Chevy Chase Lake Block B Preliminary Plan Amendment 12002020E & Site Plan Amendment 82016019D

Staff Report Date: 06.28.2021

Figure 6 – Approved circulation (left) vs Proposed circulation (right)

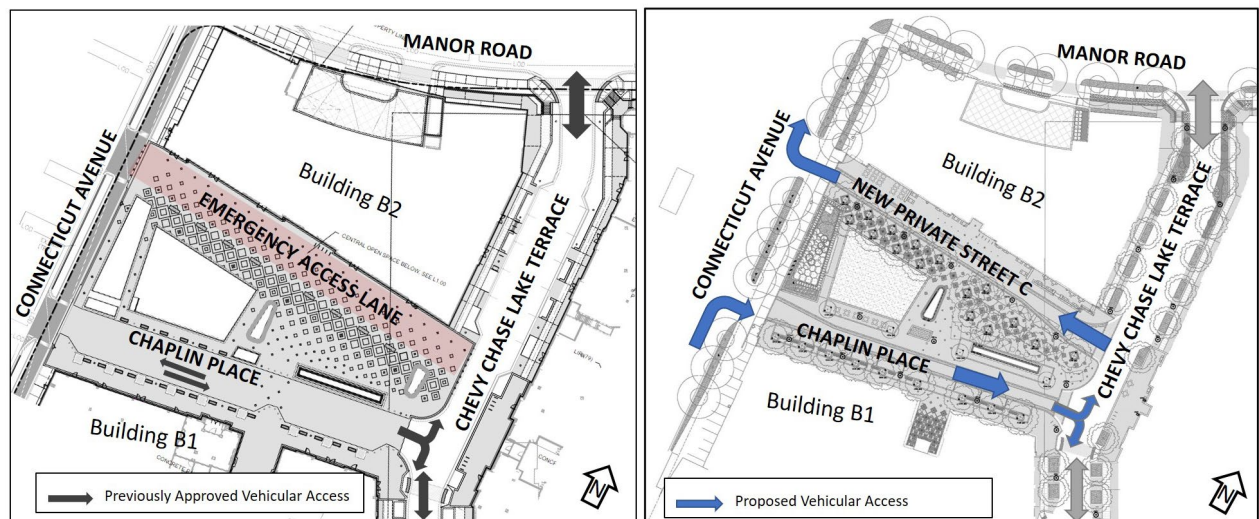
The Applicant proposes to reconfigure the circulation to create a one-way counter-clockwise loop around the central green between Connecticut Avenue and Chevy Chase Lake Terrace. Access into the

site from Connecticut Avenue will be on the south side (Chaplin Place), with return access to Connecticut Avenue on the north side (new Private Street C). The revised circulation will provide a more cohesive environment between the building facades, allowing the two narrow streets to extend the pedestrian environment from the central green to the buildings in either direction, whereas in the former, Building B1 and the dining areas were separated from the rest of the neighborhood square.

Figure 7 – Proposed Mitigation Tree modifications

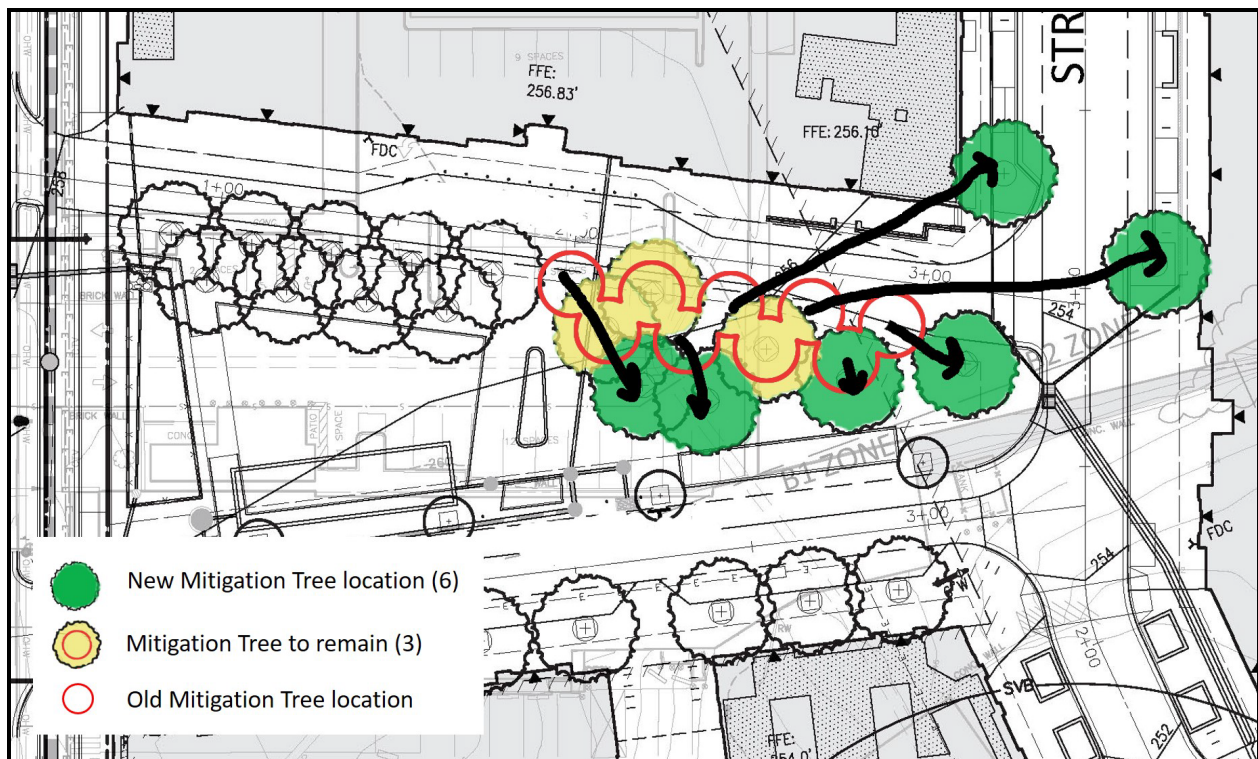
The previously approved FCP included mitigation plantings for removal of specimen trees. This Amendment will modify the locations of 6 variance mitigation plantings within the neighborhood plaza, but the required caliper inches remains unchanged. These location changes are shown in Figure 8 below. The Applicant worked with Staff to ensure mitigation trees will have sufficient soil depth and area for mature growth.

Figure 9 – Previously approved Neighborhood Square (left) Proposed Neighborhood Square (right)

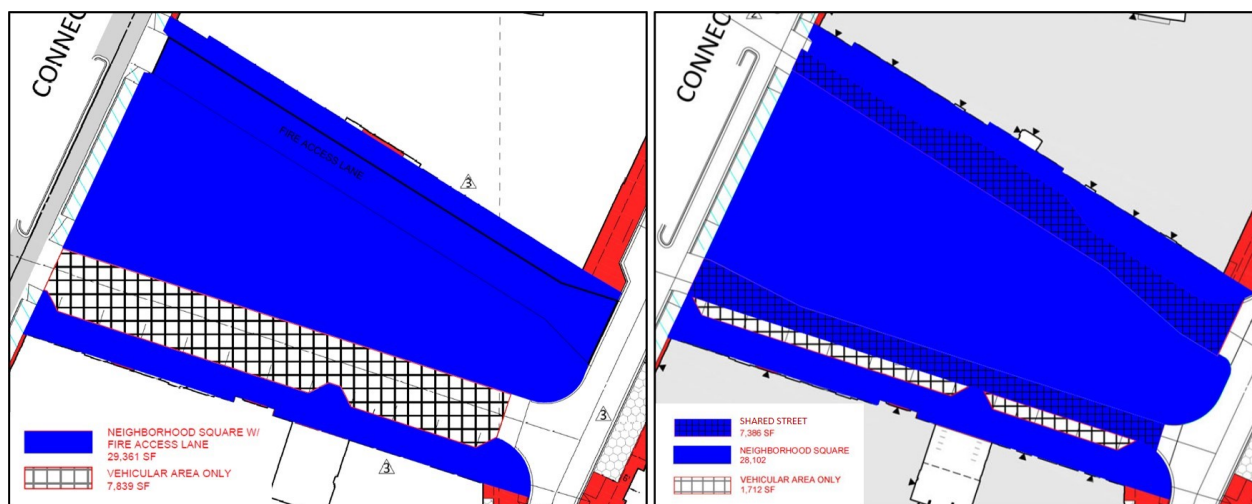
A notice regarding the subject amendment was sent to all parties of record by the Applicant on March 29, 2021. The notice gave interested parties 15 days to review and comment on the amended site plan per Montgomery County Zoning Ordinance Section 59.7.3.4.J.2. Staff received several letters from the public in opposition to the Amendments, see Attachment C. The main concern of correspondence received is that the introduction of the vehicular street in the former Emergency Access area will detract from the Sector-Planned public space/neighborhood square and reduce green space.

As previously described above, the proposed Amendments do not reduce the size between Buildings B1 and B2, rather provide a qualitative redesign of the space and internal circulation. Figure 9 below shows the comparison of the space, which demonstrates how the shared streets will provide a more cohesive environment between the building facades, allowing the two narrow streets to extend the pedestrian environment from the central green to the buildings in either direction, whereas in the former, Building B1 and the dining areas were separated from the rest of the neighborhood square. The conditioned requirements for the Sector Planned neighborhood square and the public open space continue to be met with the Amendments, and the amenities originally provided within the neighborhood square remain.
